PROPOSED STANDALONE FOOD AND DRINK POD UNIT

HYPERION TRADE PARK, ROSE KILN LANE, READING

TN01 – RESPONSE TO READING BROUGH COUNCIL COMMENTS

23RD MARCH 2023

Figure 4 – Parking Survey Extent

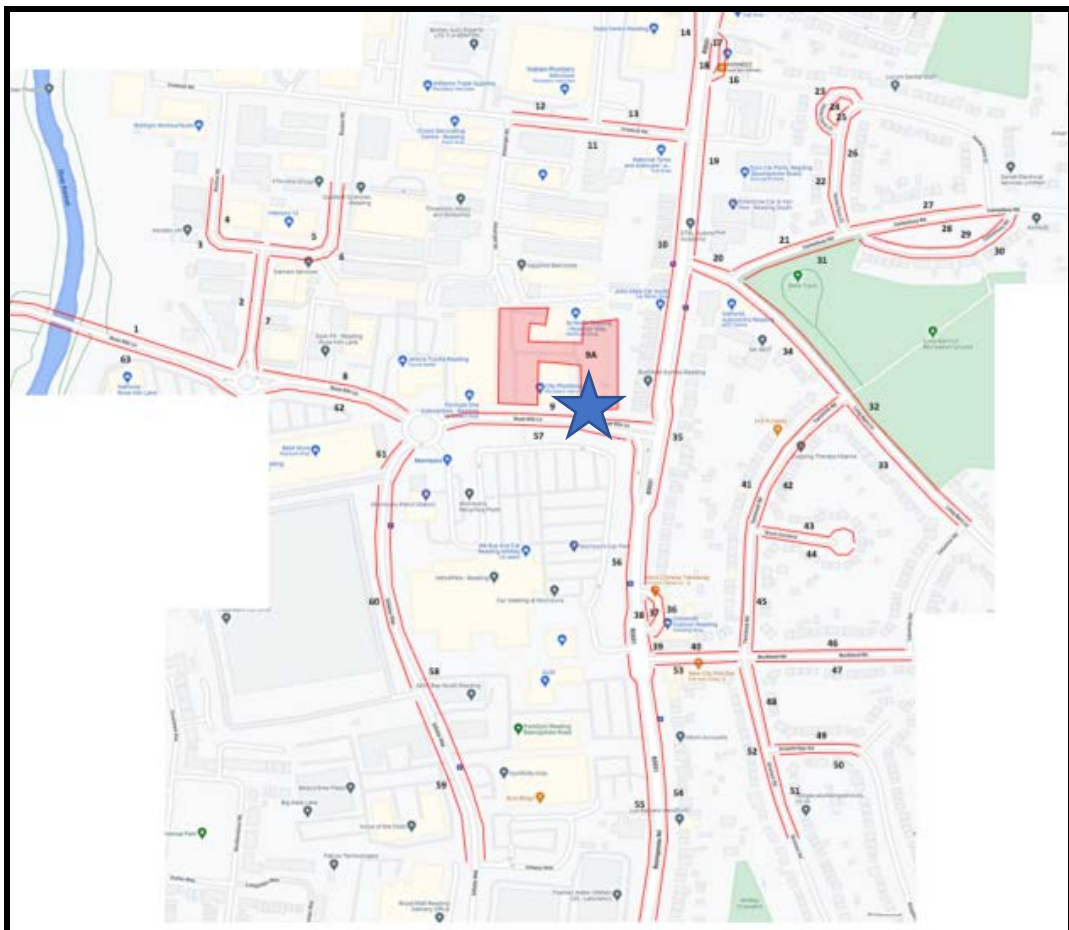
It should be stressed that this method of assessing parking as taken by the applicant is not appropriate in this case given that the site is fully operational and therefore a more accurate assessment of the existing car parking would have been to have undertaken an actual car parking surveys for the site. This would have established the actual use at the site. Given that the Highway Authority have concerns regarding the car accumulation assessment undertaken via TRICS a car parking survey must be undertaken."

- 2.51 All roads within 500m walk distance of the proposal site have been surveyed as well as the remaining lengths of road (e.g. to the next junction) as shown below.
- 2.52 Hourly parking beats were recorded between 6am and 8pm.

Figure 10 – MfS Space Width Assessment

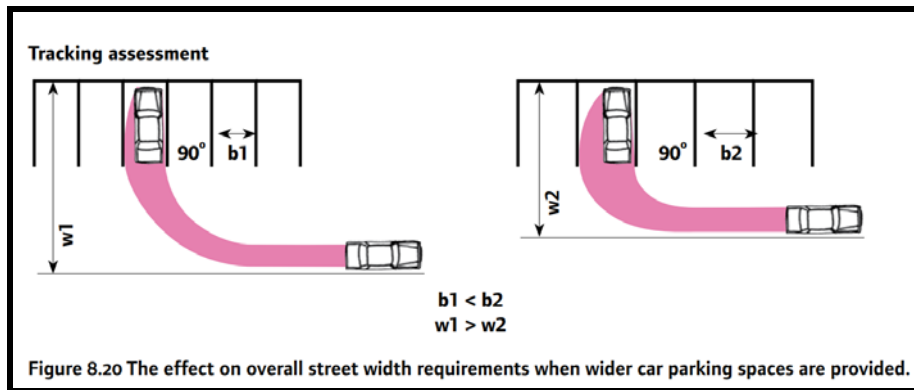
It is also noted that the tracking for the disabled bay would require the vehicle to be parked off centre to avoid conflict with the adjacent kerb. Given that a 6m forecourt depth is provided this would seem an odd parking requirement and I can only guess that this has been illustrated to remove conflict with the oncoming 12m rigid. This analysis should be updated to reflect a vehicle existing in both forward and reverse gear from the centre of the proposed bay.

- 2.73 As shown at Appendix 1, the proposed layout has been updated to move one of the disabled spaces to the north of the unit. This has resulted in loss of one parking space within the red line boundary (from eight to seven), however the disabled parking space is now more than 20m from the junction with Rose Kiln Lane (in accordance with the RBC guidance).
- 2.74 As the aisle width (of the spaces to the north of the unit) is under 6m, the width of the spaces have been increased in width in accordance with the Manual for Streets guidance shown at Figure 10 below.

Figure 11 – Parking Spaces Closer than 10m to a Classified Road

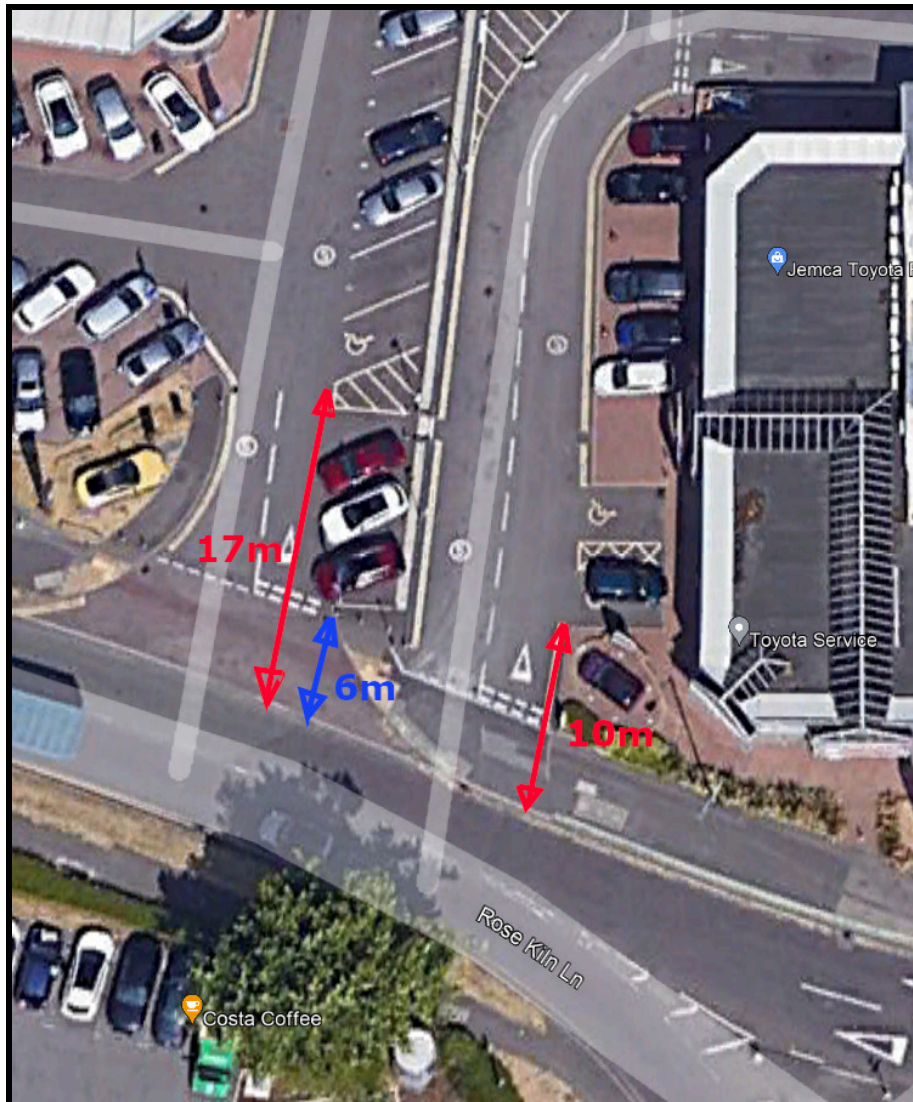
“The proposed development provides for 2 disabled parking spaces that are located 13m from the junction with Rose Kiln Lane. As identified at the Pre-Application stage these spaces would be within 20m of the junction and as such would not be acceptable. This requirement is stipulated within the Councils adopted Geometric Design Guidance for Residential Accesses on to Classified Roads and Commercial Accesses on to Adopted Roads, which states the following at paragraph 4.7:

- 2.78 In the wider area there are also a number of examples of where parking spaces (including disabled spaces) are located closer than 20m to a junction with a classified road (including Rose Kiln Lane) demonstrating the acceptability of the above. As shown at Figure 11 below.

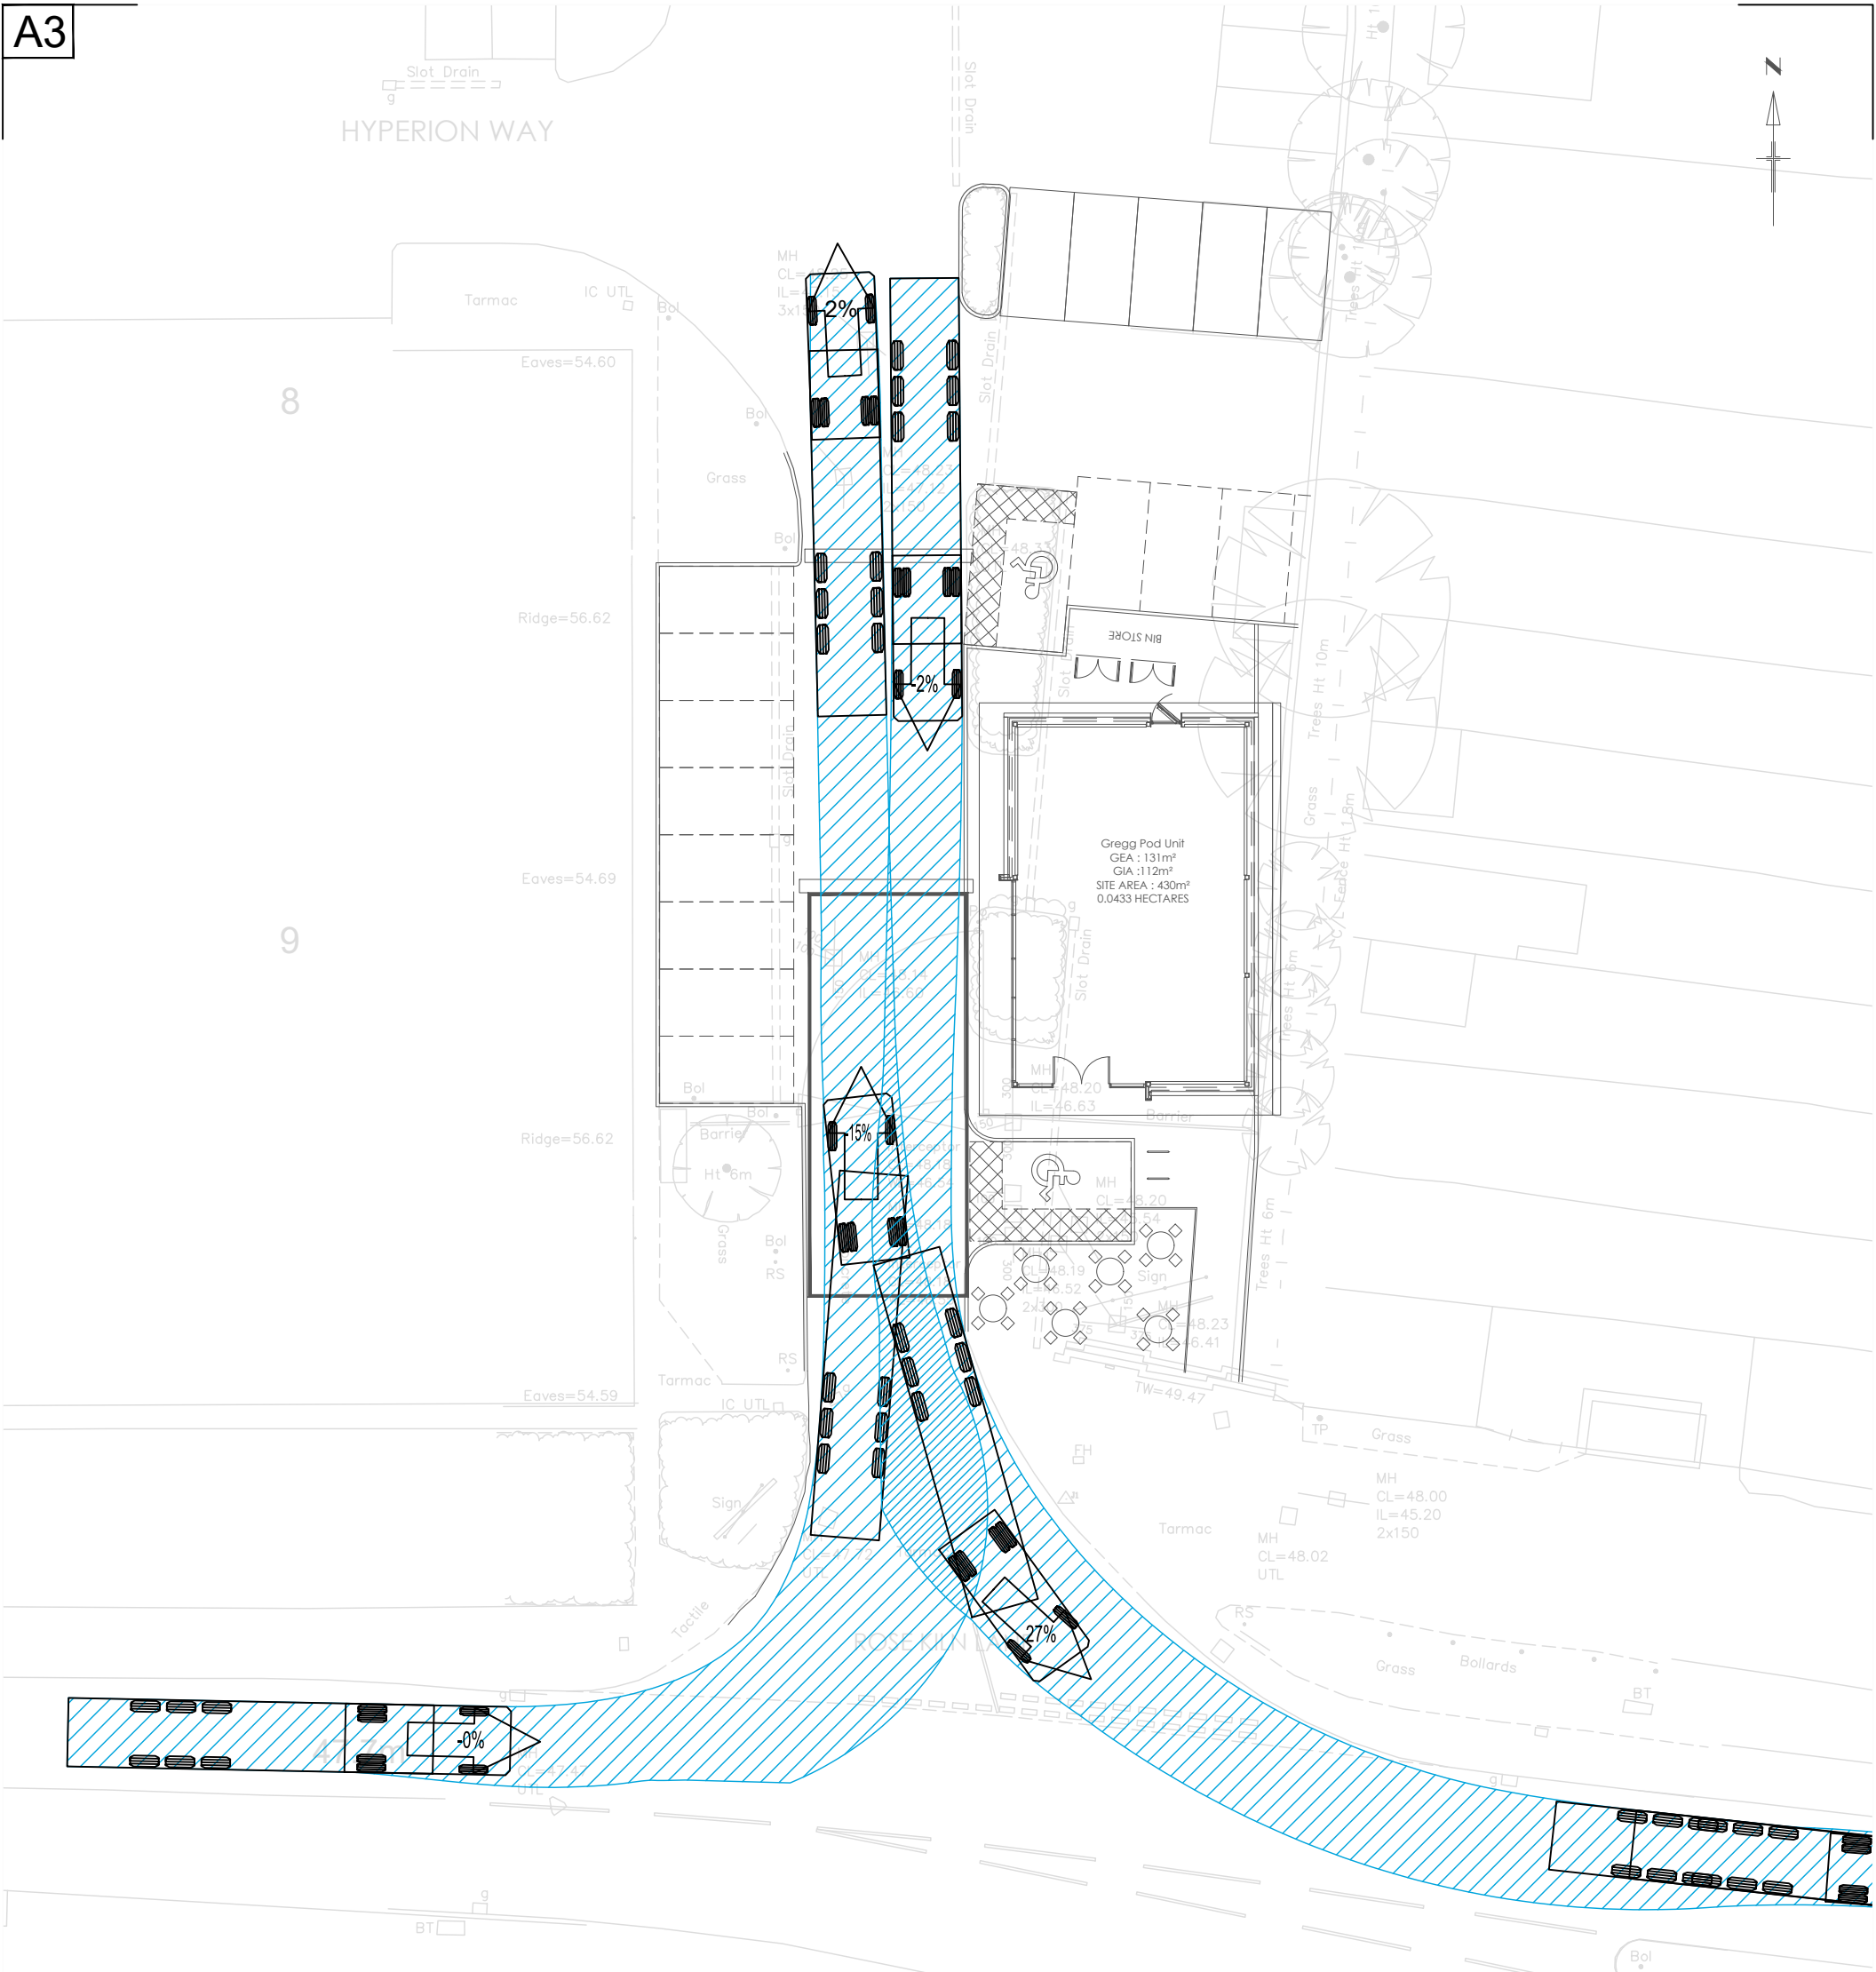
There is an area of concern in that pedestrian movements would be obstructed by the proposed external seating as this would create an obstruction for those with push chairs and in particular customers with disabilities including those accessing from the adjacent disabled bays.

To ensure that suitable access can be provided to the facility a dedicated 2m footway must be provided between the Public Highway and the Pod Unit."

Given the above a revised parking layout must be submitted relocating these spaces."

Although the Transport Statement confirms that 2 spaces would be required the proposed layout does not illustrate the provision of any cycle parking. A further assessment is therefore required to establish the correct amount of cycle parking required and also a revised drawing illustrating this provision.”

- 2.38 As shown on the updated site layout at Appendix 1 a 2m footway is shown between the edge of the public highway and entrance to the Pod. A 1.7m footway is also shown alongside the POD connecting the entrance with parking to the north.

- 2.76 As shown on the plan at Appendix 1, the proposed disabled space to the south of the unit is located almost 19m from the stop line on Rose Kiln Lane (just outside of the 20m RBC distance). Based on this the proposed development now broadly accords.

- 2.87 The updated site layout at Appendix 1 shows the 2 cycle hoops, providing parking for 4 cycles.

title
SWEPT PATH ANALYSIS
FTA DESIGN 18 TONNE 10M RIGID VEHICLE

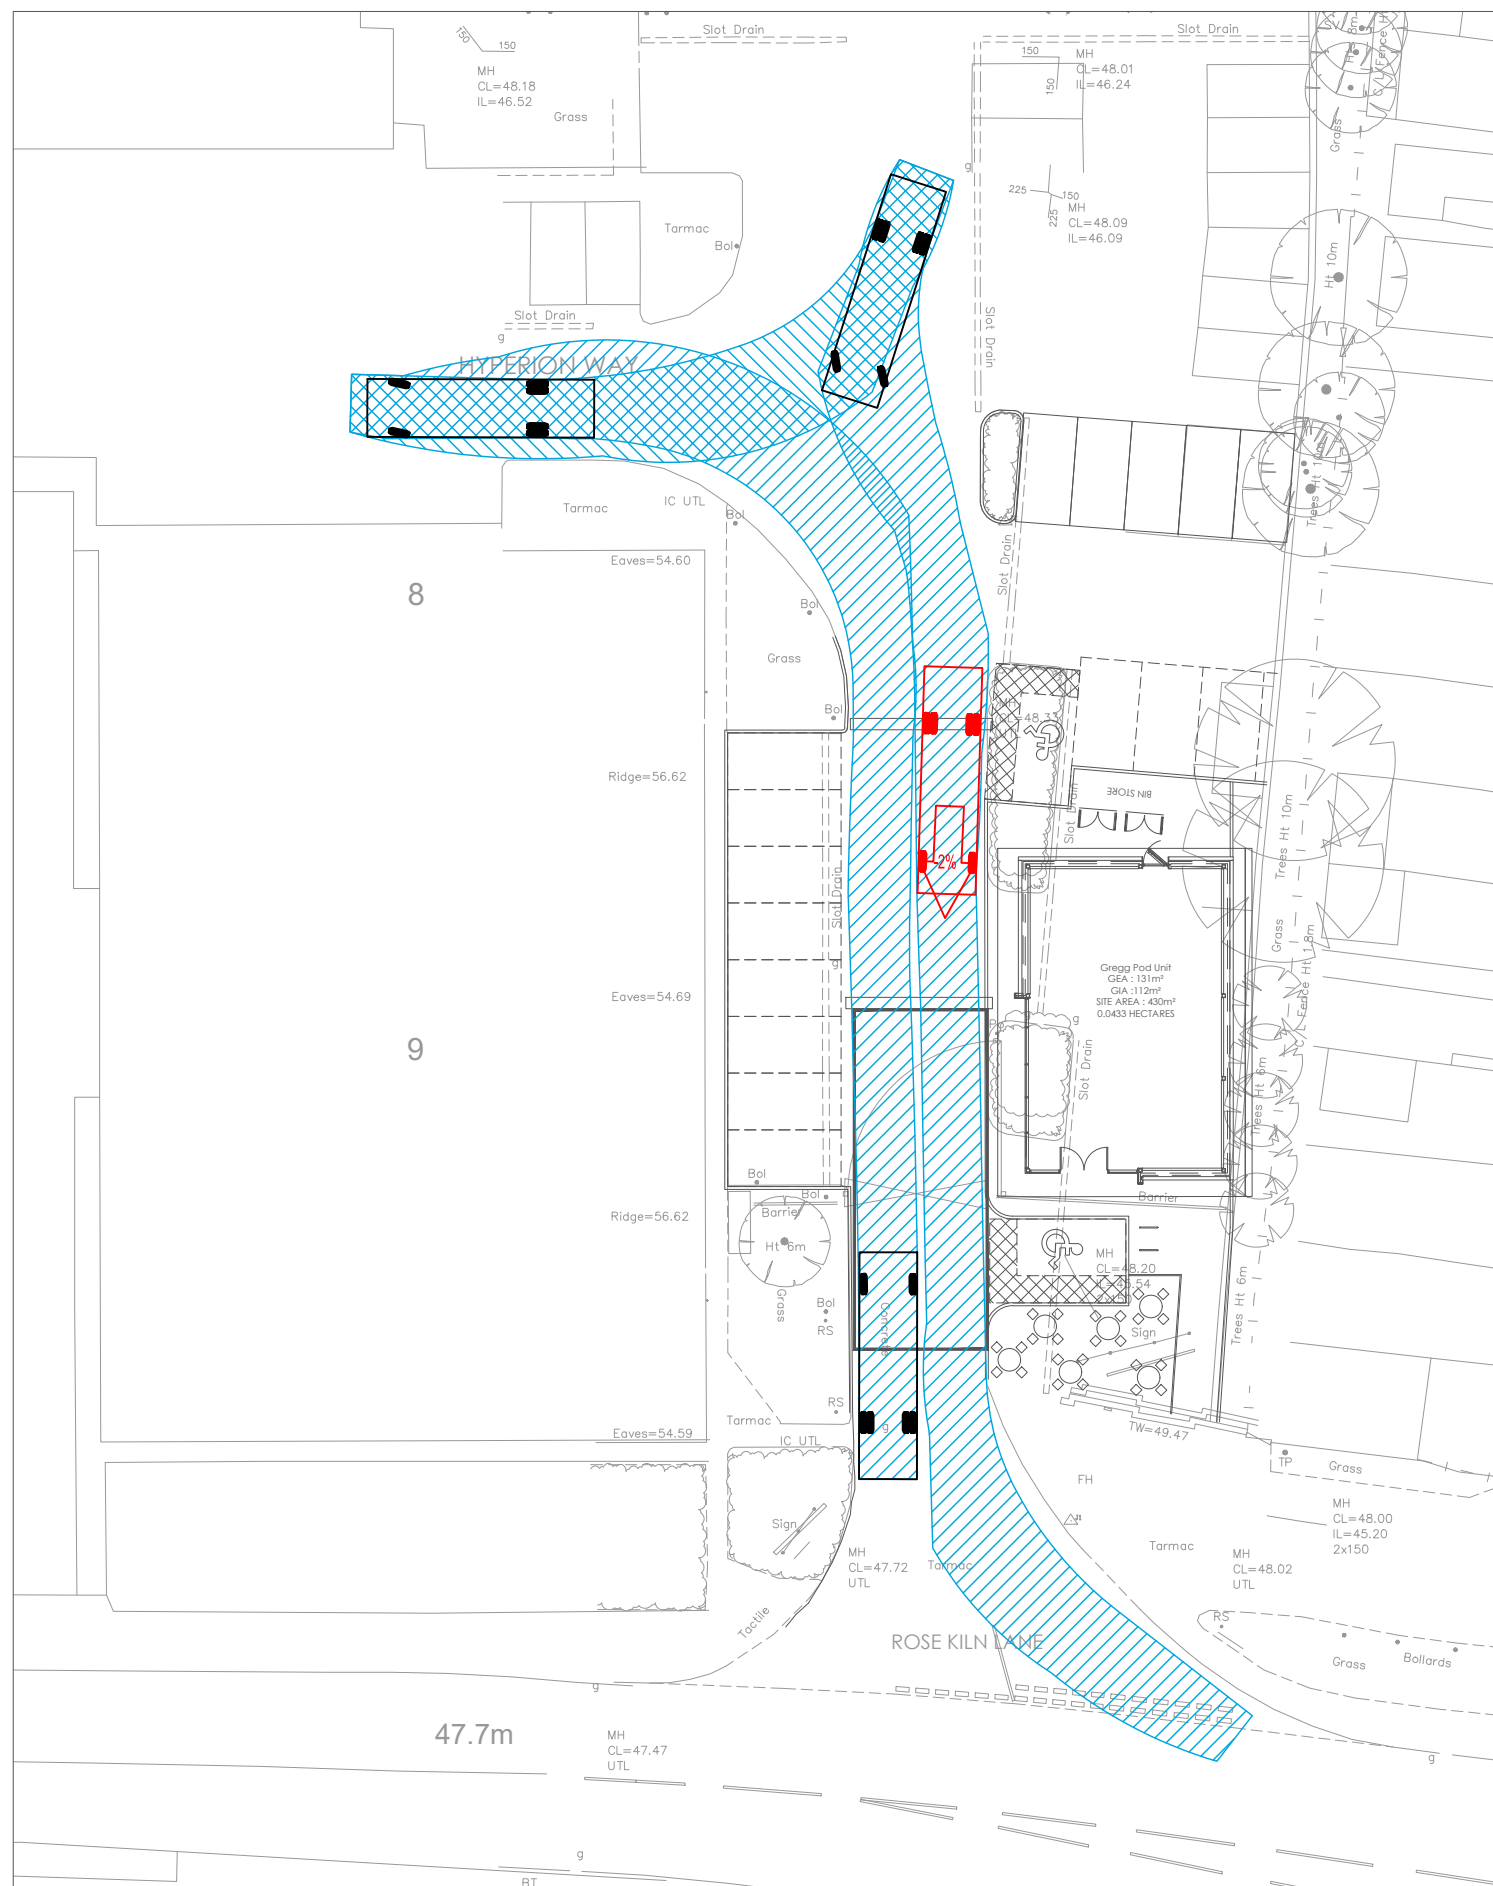
It is noted that vehicles undertaking any servicing operation will obstruct access to parking facilities dedicated to not only the proposed facility but also retained spaces for the wider Trade Park. The Highway Authority refers to the Councils Parking Standards and Design SPD that stipulates within Section 4 that a development of this proposed use and up to 500sqm requires the provision of a dedicated loading bay.

As such a revised drawing is required provided a dedicated loading facility for the Pod Unit that does not obstruct access to parking for the remainder of the Trade Estate.”

- 2.44 Swept path analysis of an 18 tonne, 10m rigid vehicle servicing the proposed Greggs is provided at Appendix 2. As detailed in the Connect October 2022 TS, servicing is proposed to be undertaken to the north of the yellow box markings.

- 2.45 The position of the service vehicle shown on the swept path drawing at Appendix 2, will disrupt / block three of the Trade Park parking spaces. The spaces are located to the rear of City Plumbing and so are more likely to be used by staff than customers.
